**From:** [Dan Grove](#)  
**To:** [Molly McGuire](#)  
**Subject:** Development Proposal Site for Permit 2207-019 is Illegally nonconforming  
**Date:** Friday, June 16, 2023 8:27:41 AM  
**Attachments:** [6950 Illegal Nonconforming Status \(1\).pdf](#)

Molly McGuire  
Mercer Island Community Planning and Development Department  
RE: Development Site for Permit 2207-019 is Illegally Nonconforming  
June 15, 2023

I'm writing to ensure that an important set of Site and Critical Area violations in SUB3 of Mercer Island Permit 2207-019 (address: 6950 SE Maker Street) are addressed. The problems I lay out about the site are in addition to the issues I've already identified around the elevation, grade, size, and setbacks for the proposed structure that I laid out in my June 9, 2023 email.

Figure 1. 1955 King County Assessor photo showing same hillside as 1963 Aerial Image in Figure 2b

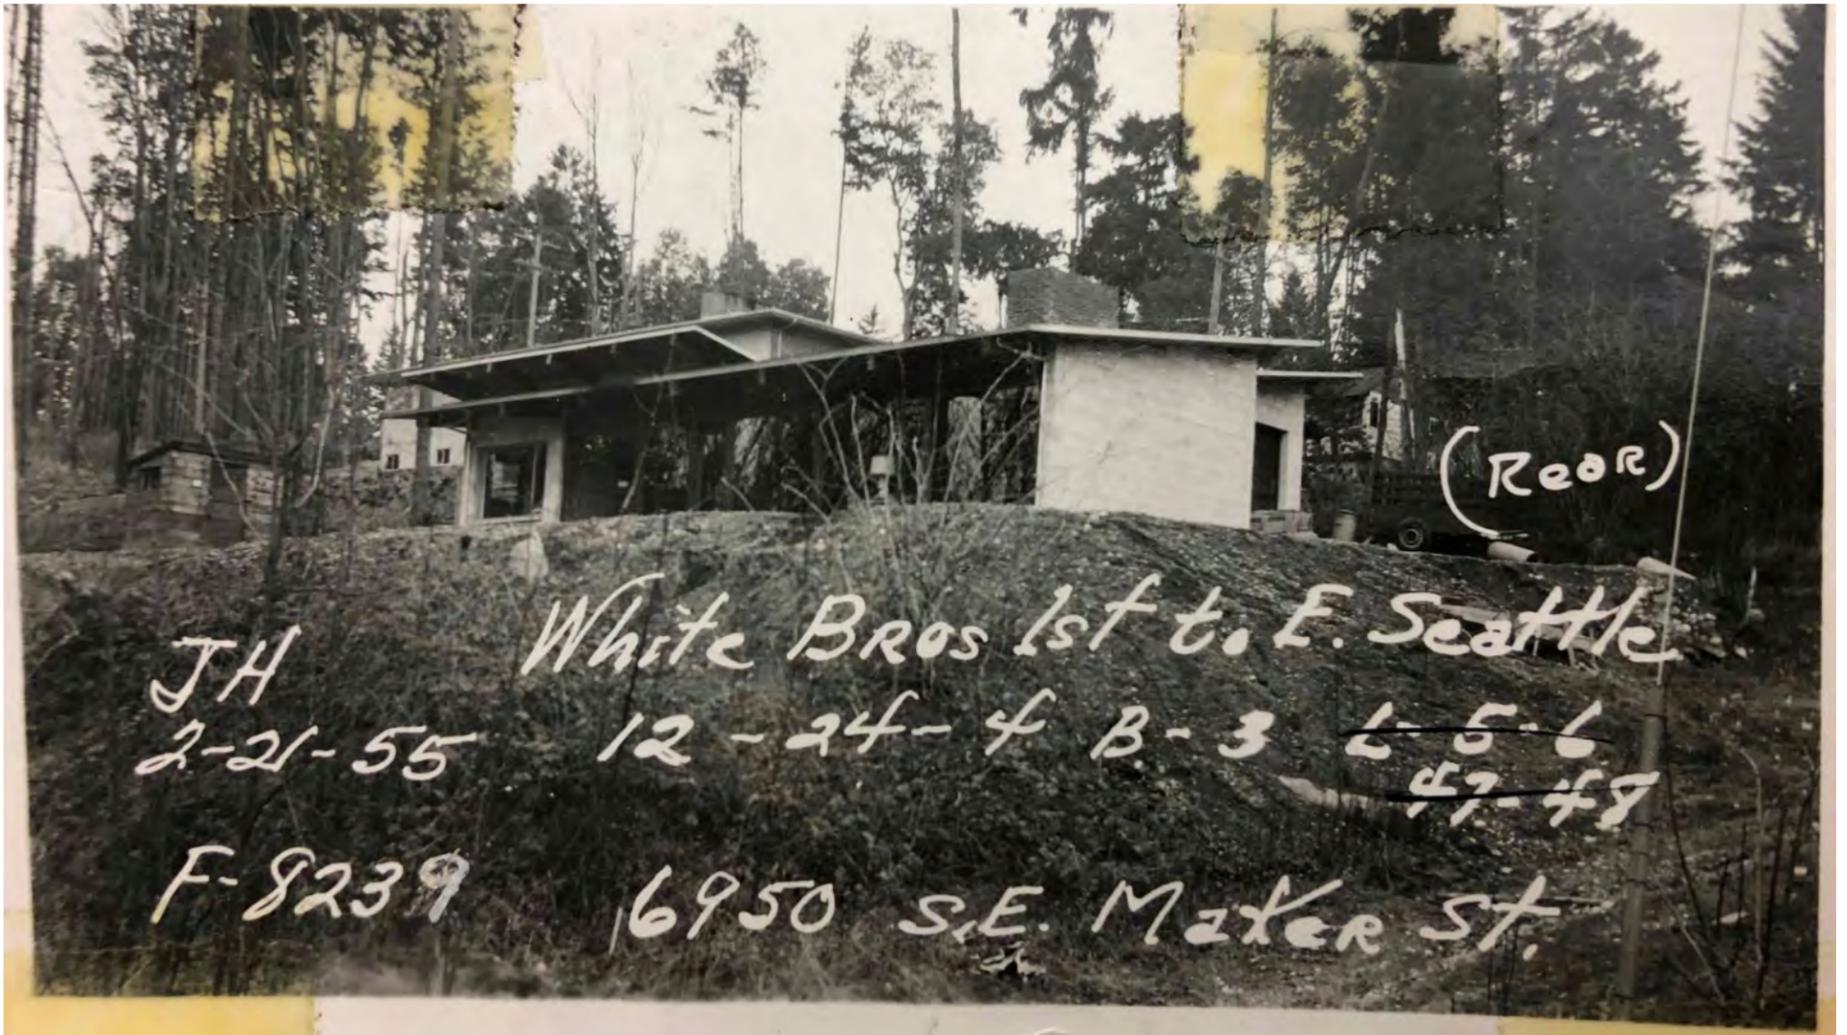
To set correct context, Figure 1 shows the Lot in 1955, before the rockery was installed.

When this photo was taken, the area directly west of the house (and shown in this photo) had approximately 10' of fill in place (based on the 1963 Survey and 2022 Geotechnical Survey, shown below).

This fill installation was the first of at least 2 major fill installations that occurred on the site over its lifetime.

Figure 2. Survey showing original grade of SE Maker Street, 1963. The grade shown for 6950 is already Altered from the Existing Grade. ("1963 Survey")

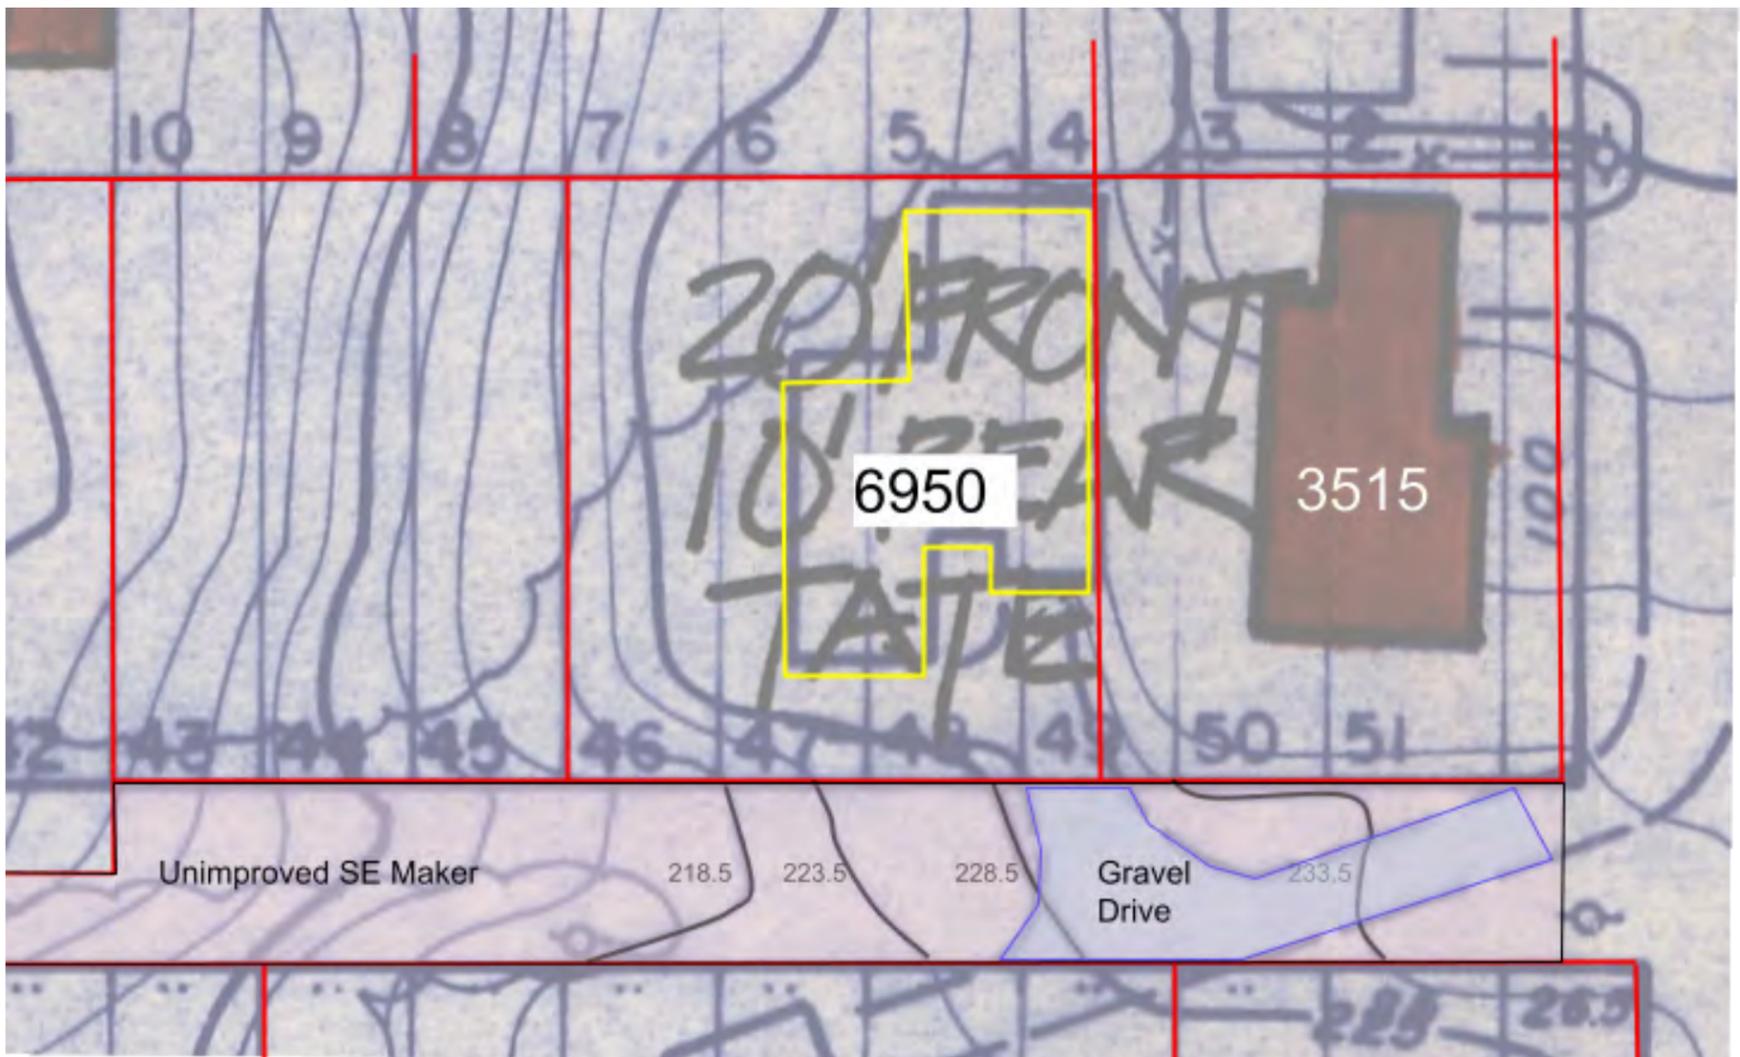
Figure 2 is taken from a [Mercer Island 1963 survey](#) that shows the contours of the Lot and the SE Maker right-of-way after the 6950 house was completed in 1955, but before the rockery was put in place around 6950.

It is important to note that there is no rockery in the SE Maker right-of-way south of 6950, and no rockery on the western boundary of 6950. This is confirmed by the 1963 aerial image in Figure 3a.

Figure 3. 2021 Survey of 6950 SE Maker and SE Maker Street

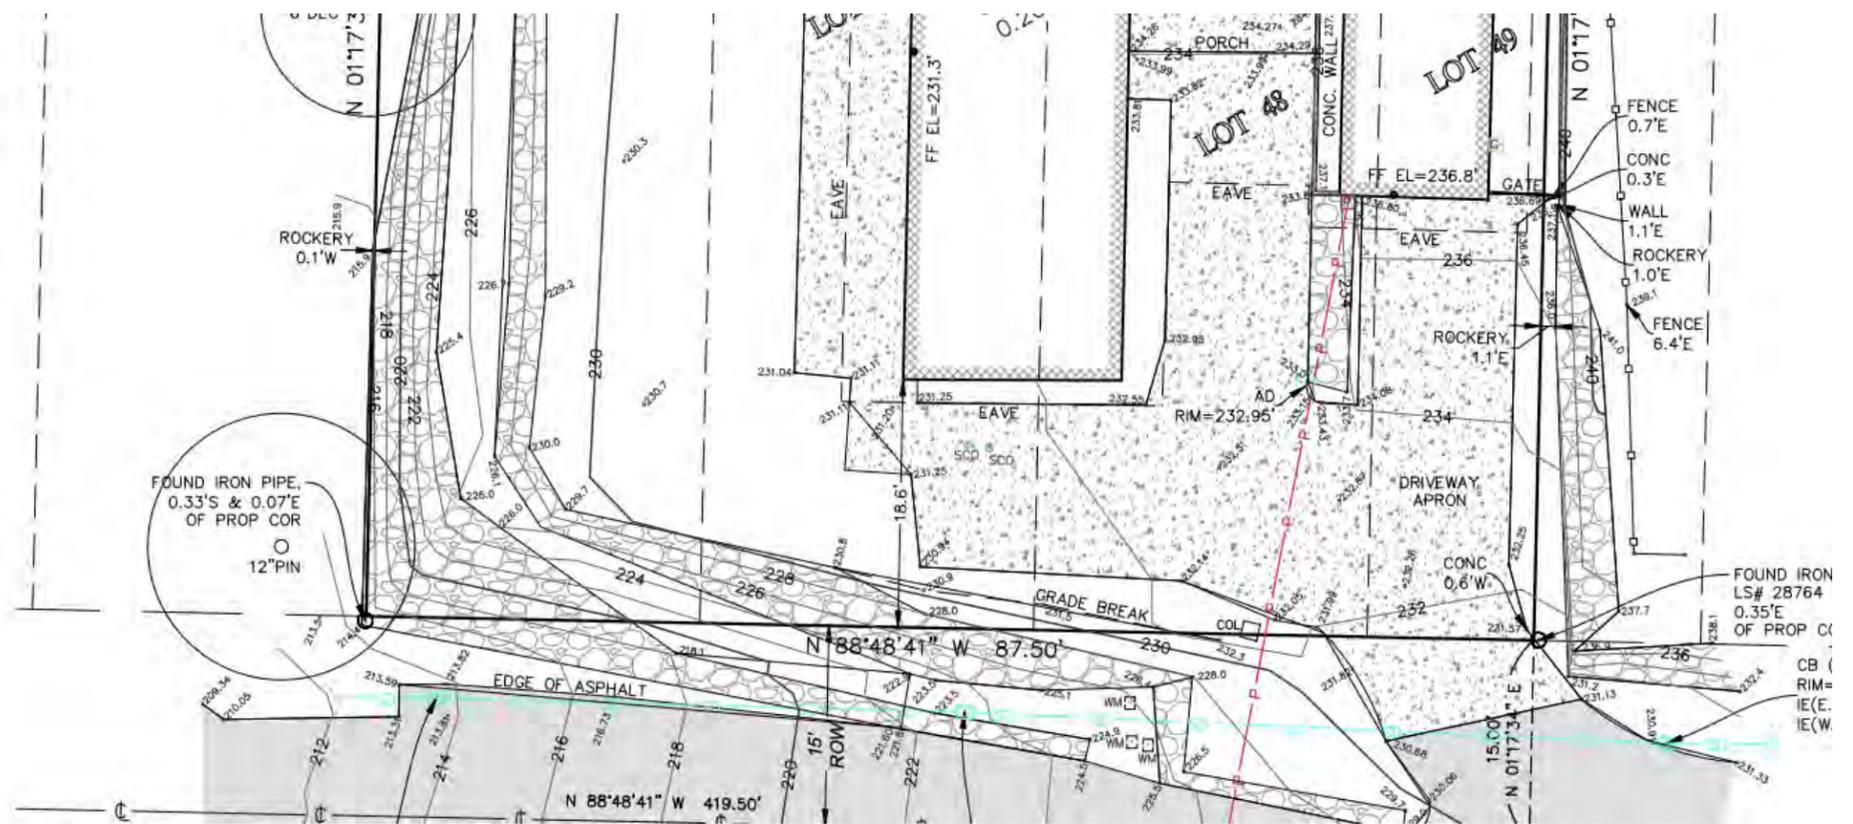
Another survey of SE Maker Street and 6950 SE Maker was done in 2021, as shown in Figure 3. The rockery installed after 1963 significantly altered the grade of the front and side yards of 6950 SE Maker (north and east of the rockery), as a second fill installation was done (to fill in the area behind the rockery, and to increase the grade of the front/side yards).

Figure 4. Comparison of cross sections of 1963 and 2021 Survey elevations

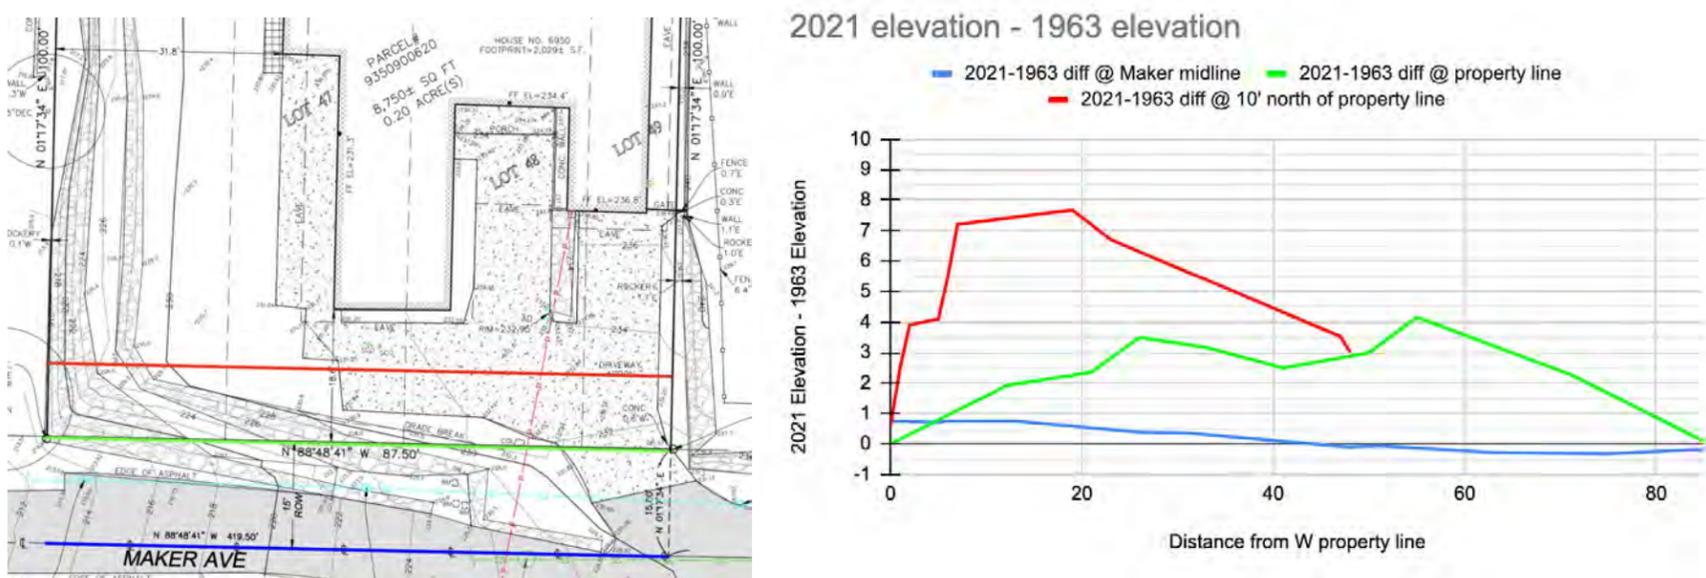
A comparison of cross sections (shown in Figure 4) of the 1963 Survey in figure with the 2021 Survey from 2207-019 clearly confirms that the rockery was installed between the dates of the two surveys. In these two surveys, 60 years apart:

- The elevation of the Maker Street midline (shown in Blue) is differs from 1963 to 2021 by only a few inches (despite the street being paved several times between the two surveys)
- At the south boundary of 6950 (in Green), the rockery that was added is clearly visible - as you can see, there are up to 4 feet of difference between 1963 and 2021.
- The cross section 10' north of the boundary (in Red) shows that the rockery increased the elevation of the yard by 7.5 feet when comparing 2021 and 1963 elevations.
